**DEPARTMENT OF PLANNING AND COMMUNITY DEVELOPMENT
STAFF REPORT**

PLANNING COMMISSION AGENDA ITEM # 3	
Project Name:	Tread of Pioneers Museum – Collection Building Addition (Original Town of Steamboat Springs, Blk 8, Lot 11-12) #DPF-11-02
Prepared By:	Seth Lorson, AICP, City Planner (Ext. 280)
Through:	Tyler Gibbs, AIA, Planning Director (Ext. 244)
Planning Commission (PC):	December 8, 2011
City Council (CC):	December 20, 2011
Zoning:	Commercial Neighborhood (CN)
Applicant:	Tread of Pioneers Museum PO Box 772372 Steamboat Springs, CO 80477 (970) 879 - 2214
Request:	A Development Plan/Final Development (PUD) Plan for the addition of a 3,215 S.F. collection building, plus a 1260 S.F. basement.

Sheet Number
 FDP-3.0

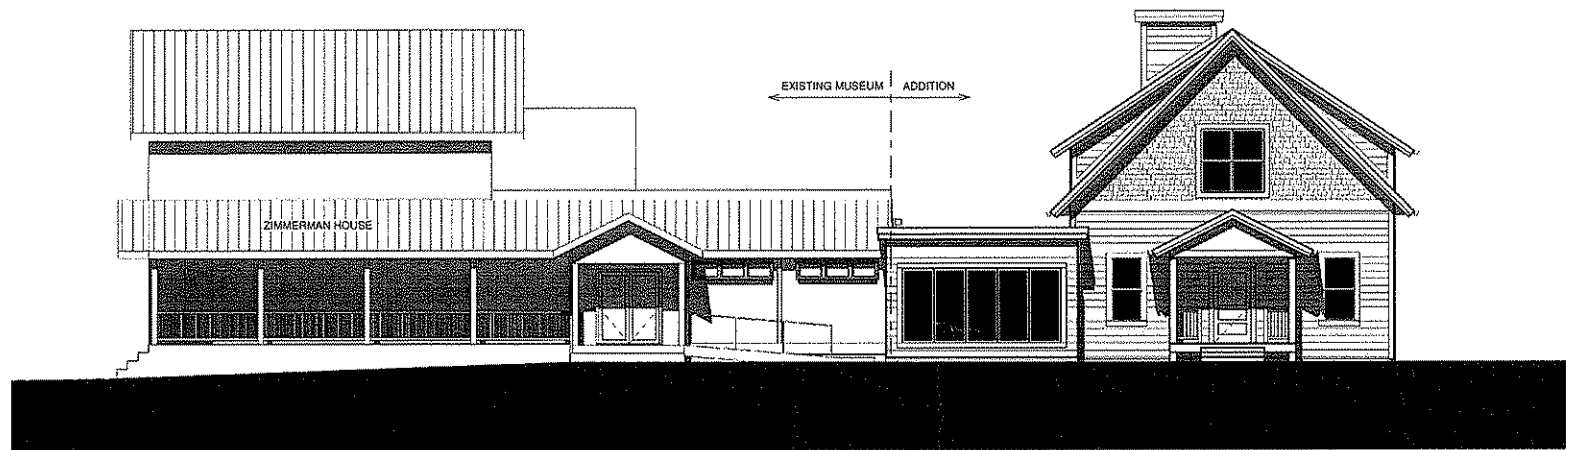
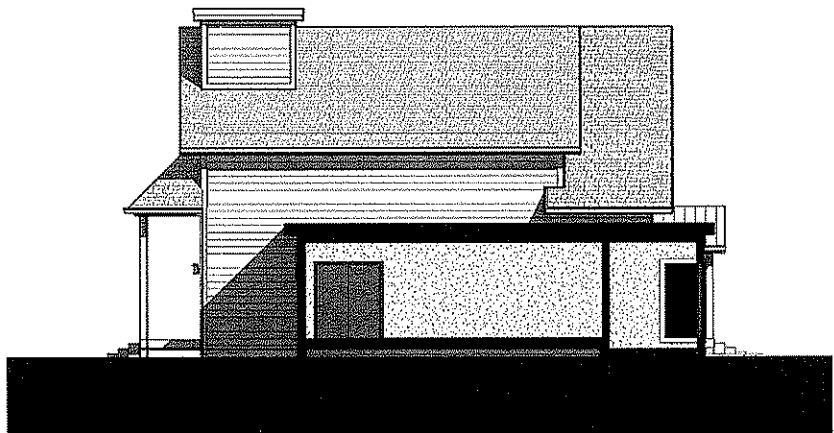
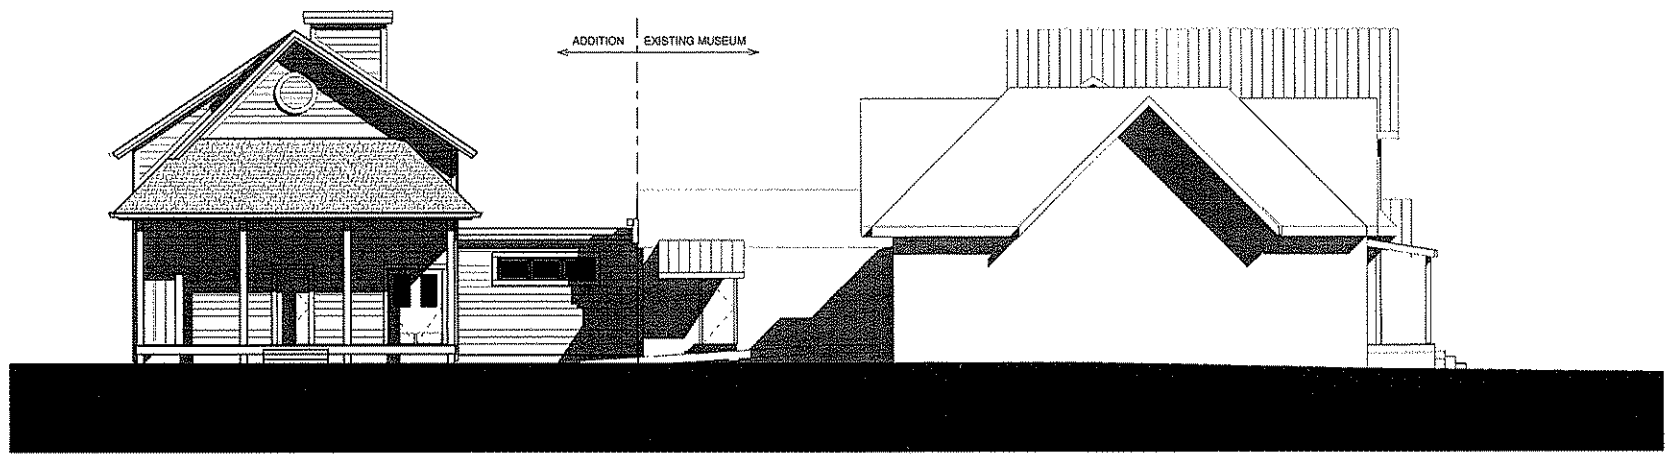
- a. **Legal Use:** *Staff Analysis:* **Consistent.** No change of use is proposed.
- b. **Injury to Adjoining Property Mitigated:** *Staff Analysis:* **Consistent.** The existing collections building encroaches nine feet into the side setback. The proposed building encroaches five feet with a three foot eave overhang. The proposed roof has been fitted with asphalt shingles and snow fences to avoid snow shedding into the alley.

1. Building roofs may not shed snow or drip roof drainage into public ROW or onto sidewalks. Rain gutters, snow anchors and/or snow fences shall be installed on the alley side roof to prevent rain and snow from falling onto the public ROW.
2. Include the following conditions of approval:
 - a. The following items to be identified for each phase on the building permit are considered critical improvements and must be constructed prior issuance of any TCA or CA; they cannot be bonded:
 - Public sidewalk improvements or repairs
 - Access drive, driveway, and parking areas
3. If the scope of the project changes and the existing collections building is to be moved, an amendment to this approval is required.
